MARICOPA COUNTY
Department of Transportation

MEMORANDUM

Date: January 15, 2013
To: MAG Specifications and Details Committee
From: Robert Herz, MCDOT Representative
Subject: Correction to Detail 501-5

Case 13-01 D

DETAIL NO. 501-5	STANDARD DETAIL ENGLISH	HEADWALL DROP INLET	REVISED 01-01-1998	DETAIL NO. 501-5
----------------------------	----------------------------	----------------------------	-----------------------	----------------------------

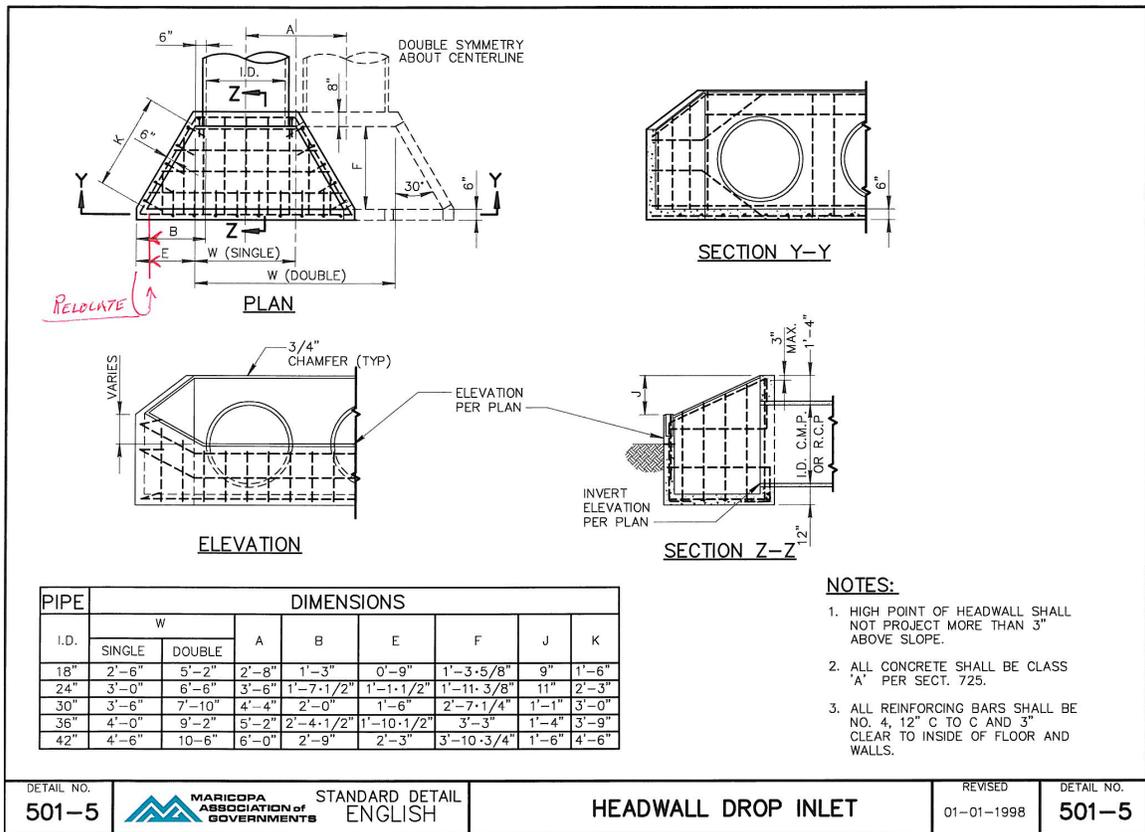
PURPOSE: Correct depicted distance B and E shown on PLAN view of Detail 501-5.

Variable distance B and E shown on the PLAN view are presently shown to the outside edge of the inlet basin wall, they should be shown to the inside edge of the inlet basin wall.
 (Distances E and F are the legs of a right triangle with hypotenuse K.)
